GUADALUPE - COYOTE  
RESOURCE CONSERVATION DISTRICT

**Subject: Draft Environmental Impact Report for Coyote Valley Specific Plan,  
File No. GP 06-02-04 (SCH# 2005062017)**

## **COYOTE VALLEY SPECIFIC PLAN Draft EIR Comments**

## ATTACHMENT I

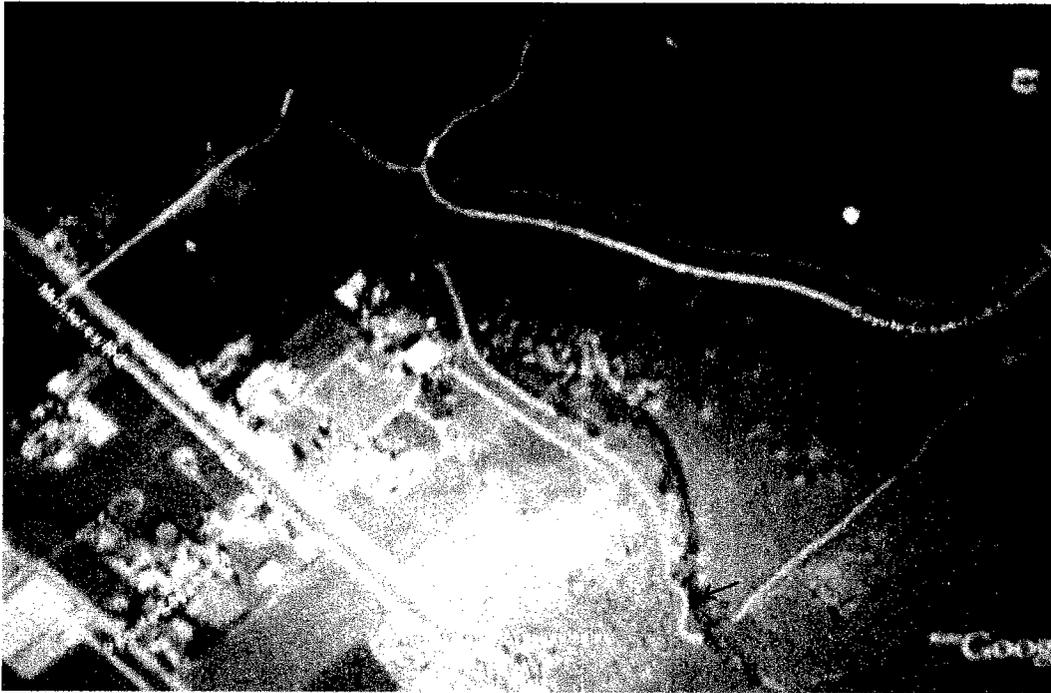
moved out of the area is not replaced by new sediment, which is trapped above the dams, the creek channel is degrading. Any one can clearly see evidence of this just by looking at the eroding creek channel below Anderson Reservoir, ref. Attachment I, 1<sup>st</sup> 3 photos.

Coyote Creek, north of the Model Airplane Park, May 11, 2002. Failing east bank has taken out a paved trail and maintenance road. Large clumps of bank vegetation are sloughing off and falling into the channel.

## ATTACHMENT I

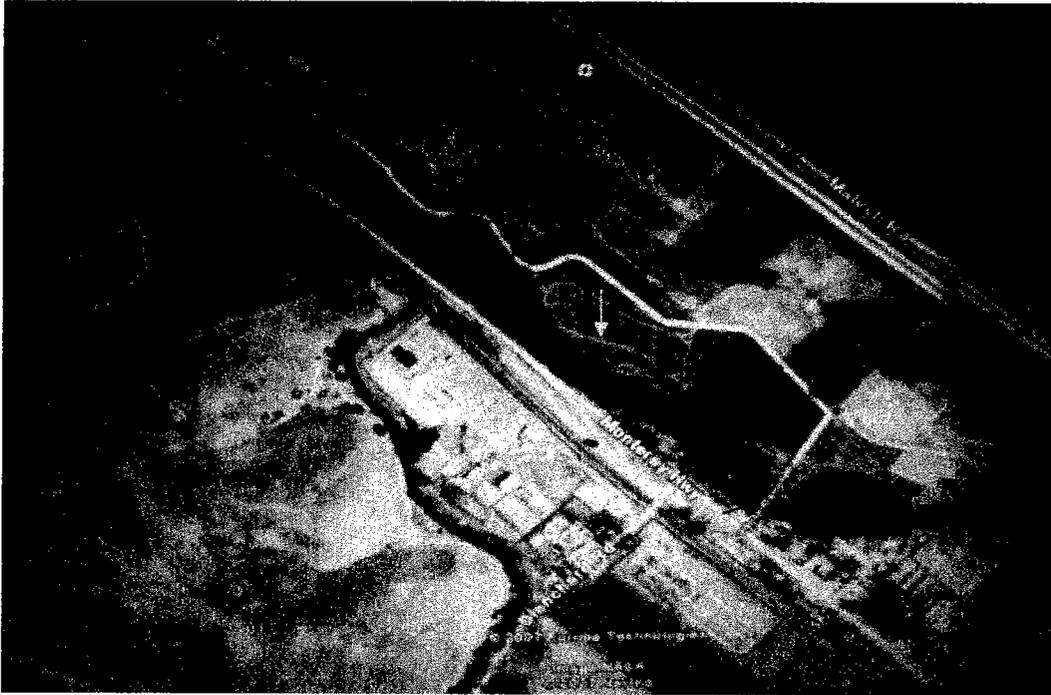
View upstream at very narrow creek channel and corridor upstream of the Coyote Ranch Road crossing.

View of three extremely small culverts under Coyote Ranch Road. These culverts do not have the capacity to pass even the small storm flows and the potential for becoming clogged with debris and sediment is very high.

## ATTACHMENT II

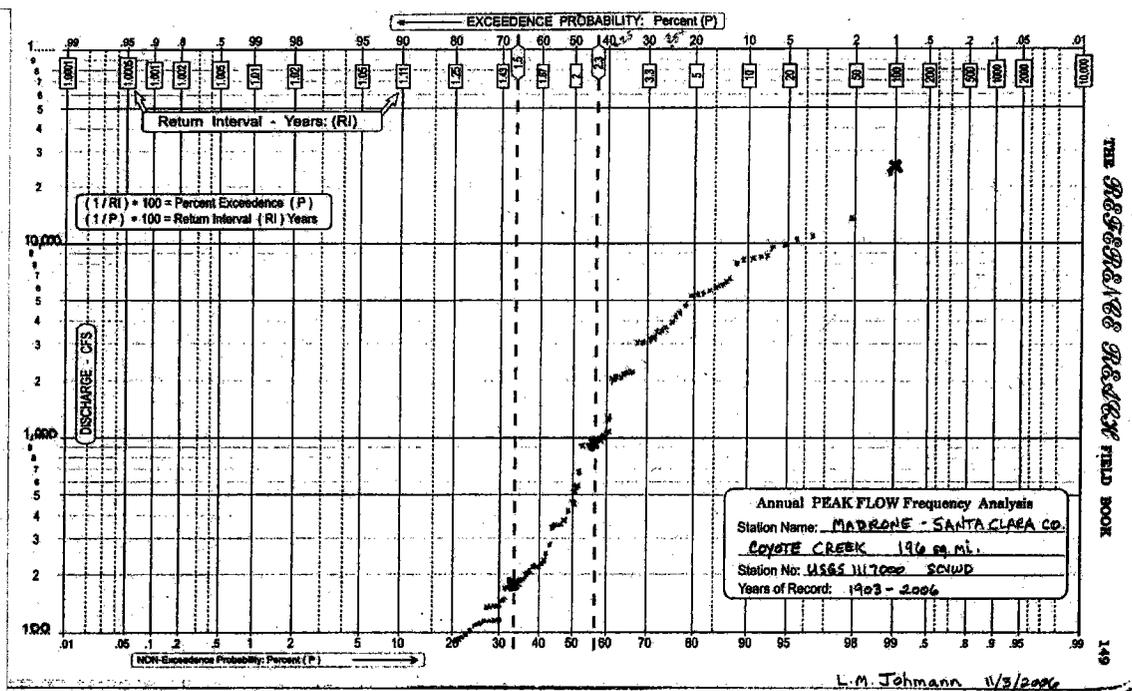
Fortunately there are two long time stream gage stations along Coyote Creek near the project area. The Madrone gage, not too far upstream of the project area, has been in operation since 1903 and the Edenvale gage has been in operation, not far downstream of the project area, since 1917. Analysis of the Madrone gage data from 1903 to 1950, prior to construction of Anderson Dam, shows that the bankfull flow of the creek to be about 2000 cfs (the creek constructed its active channel to carry a flow of about 2,000 cfs before it would flood). In order to carry a 2,000 cfs flow, while remaining relatively stable, a channel cross section of about 400 ft<sup>2</sup> (about 80 ft. wide and 5 ft. deep) would be needed. Analysis of the Madrone gage data from 1903 to 2006 shows that the bankfull flow to be about 180 cfs. A channel cross section of about 40 to 50 ft<sup>2</sup> would be needed to carry this flow. The significant reduction in the gage projected bankfull flow is a direct result of the detention of high flows by Anderson Dam. Analysis of the Madrone gage data from 1951 to 2006 shows that the bankfull flow, using only post dam data is about 90 cfs. A channel cross-section of less than 25 ft<sup>2</sup> (20 ft wide and 1.2 ft deep) would be necessary to contain this bankfull flow. Analysis of the Edenvale gage data shows even lower peak and bankfull flows, although the station monitors a 33 mi<sup>2</sup> larger drainage area. The lower readings downstream are almost assuredly caused by out of channel flood flows and instream water impoundments or diversions between the two gage stations. There is ample evidence along Coyote Creek, in the project area, that the bankfull channel cross section dimension is no where near 400 ft<sup>2</sup>. It is much closer to 50 ft<sup>2</sup> and in some cases even smaller. The bankfull channel dimensions are also greatly varied. In some locations the channel is quite wide but not very deep (50 ft wide and 1 ft deep) and in other areas is much narrower but deeper (25 ft wide and 2 ft deep). The above is a clear indicator that the channel is unstable and decreasing in size, as a result of being deprived of adequate channel forming and maintenance flows and a proper sediment regime. Unless something is done to correct this situation, the creek will continue to decrease its channel size. Because the creek channel has significantly reduced its size since the construction of Anderson Reservoir, it is currently unable to handle even small storm event flows without major out of channel and out of corridor flooding. Not only are inadequate flows seriously degrading the channel, its riparian corridor and fish/aquatic habitat, they have and will continue to greatly increase the risk of damaging flooding downstream from increasingly smaller events, as the channel continues to decrease in size. When larger storms hit, neither the channel nor its corridor (floodplain area), will have the capacity to handle the high flows, so they will overflow to the northwest and inundate the project area. They will eventually end up detained or confined in the Laguna Seca natural wetland area, ref, Attachment I photos and Attachments II & III, gage station peak flow information/return interval analysis.

Bankfull ~ 2,000 cfs      Mean Annual Flood ~ 4,800 cfs      100-Yr. Flood ~ 30,000 cfs  
 Madrone Gage Station, 196 mi<sup>2</sup> Drainage - 1903 to 1950 Data (Pre Anderson Dam)

Bankfull ~ 180 cfs      Mean Annual Flood ~ 900 cfs      100-Yr. Flood ~ 28,000 cfs  
 Madrone Gage Station, 196 mi<sup>2</sup> Drainage - 1903 to 2006 Data (Full Data Set)

## ATTACHMENT II

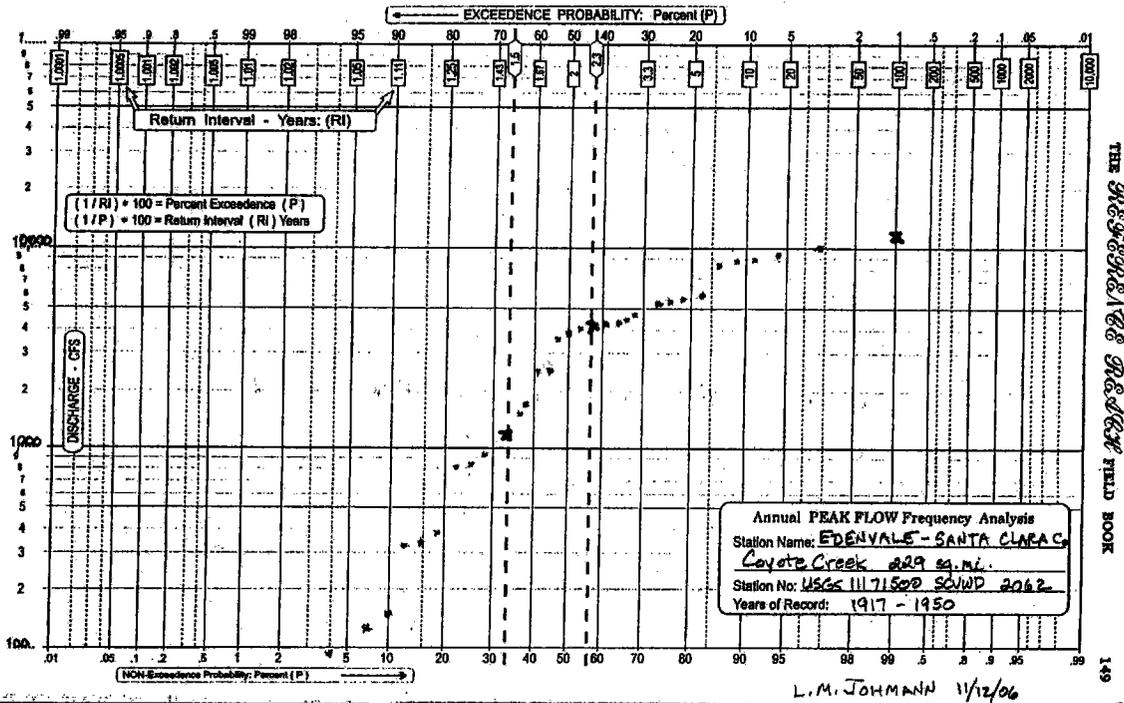
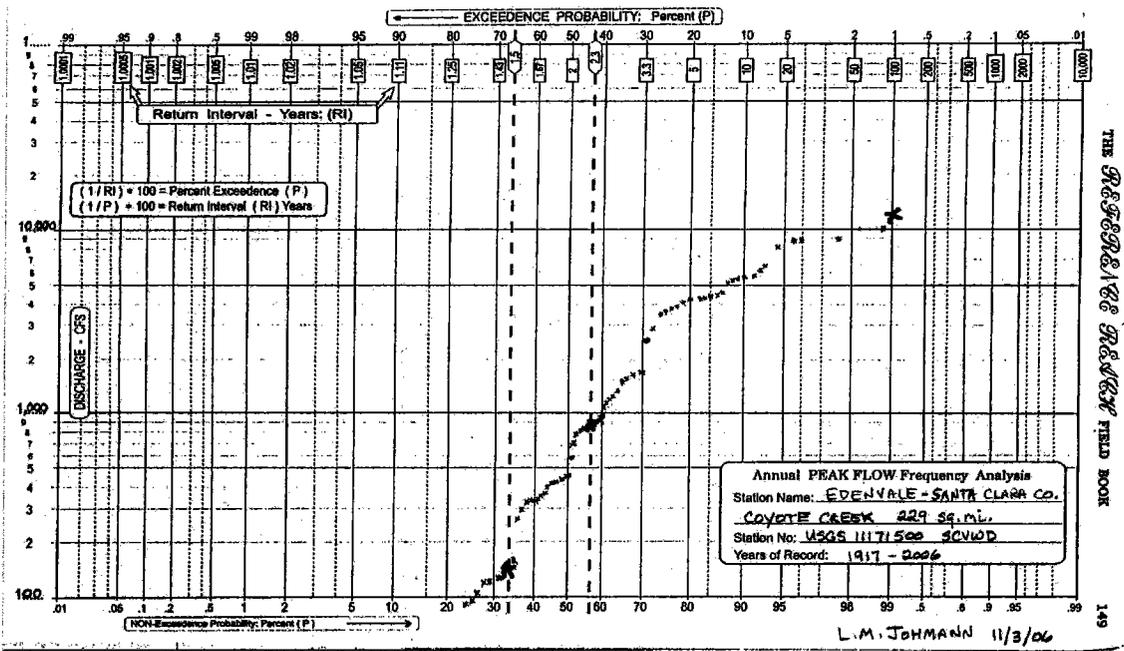
Bankfull ~ 1,100 cfs      Mean Annual Flood ~ 4,200 cfs      100-Yr. Flood ~ 12,000 cfs  
 Edenvale Gage Station, 229 mi<sup>2</sup> Drainage - 1917 to 1950 Data (Pre Anderson Dam)

Bankfull ~ 140 cfs      Mean Annual Flood ~ 900 cfs      100-Yr. Flood ~ 11,000 cfs  
 Edenvale Gage Station, 229 mi<sup>2</sup> Drainage - 1917 to 2006 Data (Pre Anderson Dam)

## ATTACHMENT II

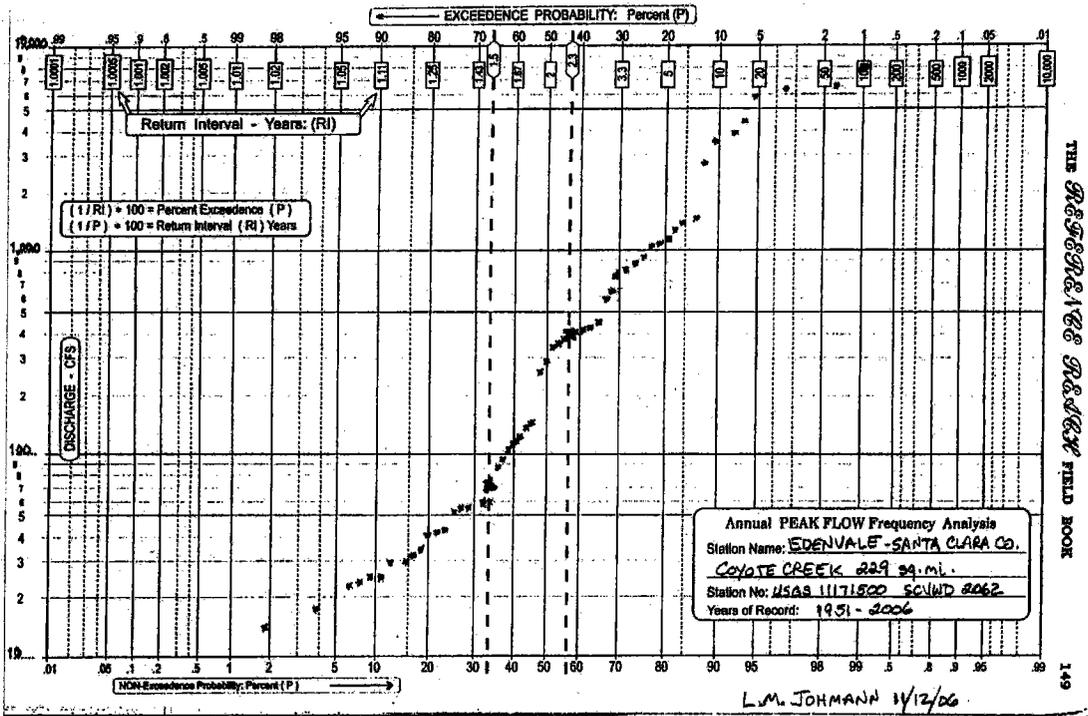
Bankfull ~ 75 cfs      Mean Annual Flood ~ 400 cfs      100-Yr. Flood ~ 8,000 cfs  
 Edenvale Gage Station, 229 mi<sup>2</sup> Drainage - 1951 to 2006 Data (Pre Anderson Dam)

Annual Peak flow data from rivers with natural and quasi natural flows plot as a sloping line on log Pearson paper. A best fit convex curved line projected through the data points give extrapolated flows such as the projected 100-year flow. Note the data from 1903 to 1950 plot and the 1903 to 2006 plot show a more regular sloping line but the bankfull and mean annual flows are significantly lower in the 1903 to 2006 plot because of excessive water impoundments and diversions post dam construction. The effects of the post dam impoundments and diversions can be clearly seen in the 1951 to 2006 plot. The plot is very irregular and the data does not accommodate a best fit curve. The bankfull, mean annual and 100-year flows are excessively low. Published data from waterways studied in the San Francisco Bay area show the bankfull flow for a 200 mi<sup>2</sup> drainage area to be between 2500 to 6000 cfs.
